**BROWNS FERRY
EXAM 2002-301
50-259, 50-260, & 50-296**

**BROWNS FERRY NUCLEAR PLANT (BFN) - COMMENTS TO NRC WRITTEN
EXAMINATION QUESTIONS**

The Enclosure contains comments on questions 27, 44, and 50 in the Reactor Operator examination prepared by your staff. Pursuant to the ES, these comments were provided in draft form to the NRC Chief Examiner, Mr. Edwin Lea.

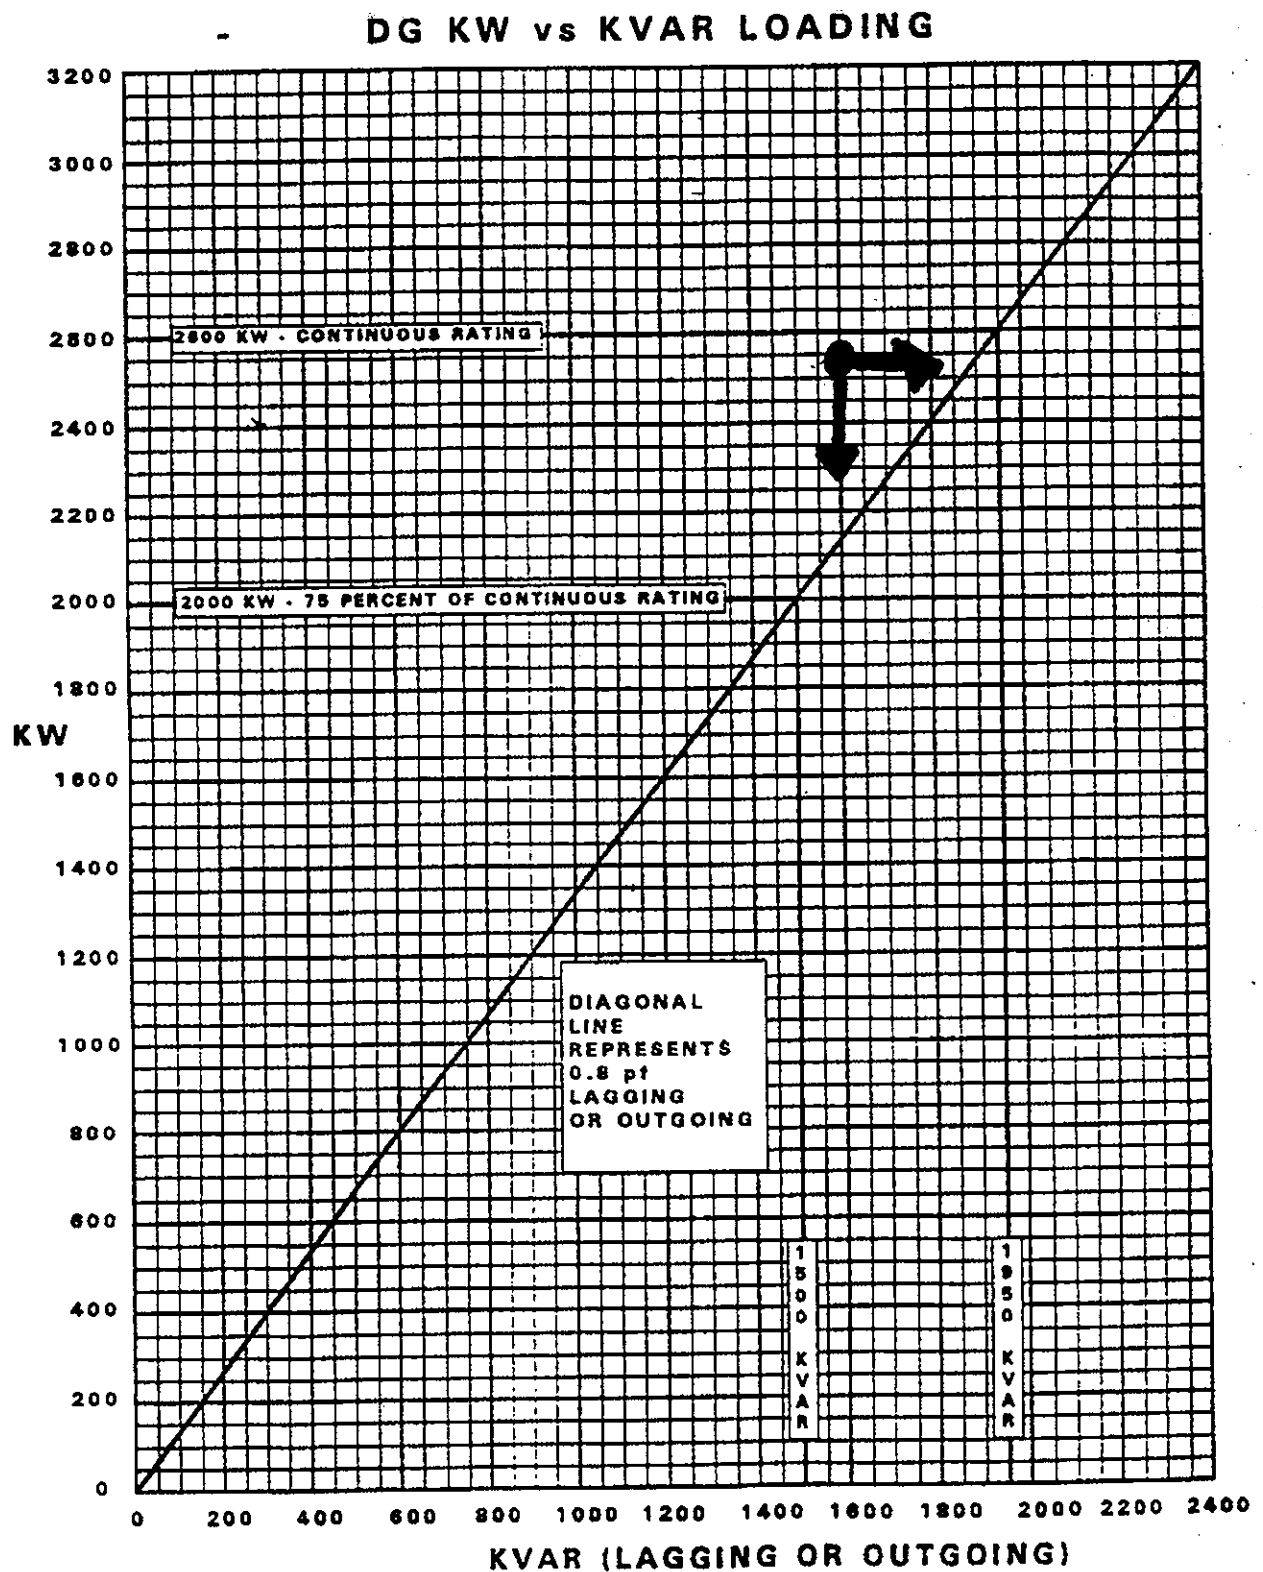
In reviewing the question, we believe both "A" and "C" are correct. The basis is as follows:

"A" and "C" both reflect correct responses for these generator conditions. In accordance with OI-82, Standby Diesel Generator System, Step 8.1.12, the required 0.8 power factor may be achieved either by placing the Voltage Regulator Switch to the RAISE position or by placing the Governor Control Switch to the LOWER position in order to reach the diagonal line on Illustration 1, DG KW vs KVAR LOADING.

Since the question only asks for a correct required action (and not the supporting reason), both "A" and "C" are correct.

Proposed disposition: Accept either "A" or "C" as correct
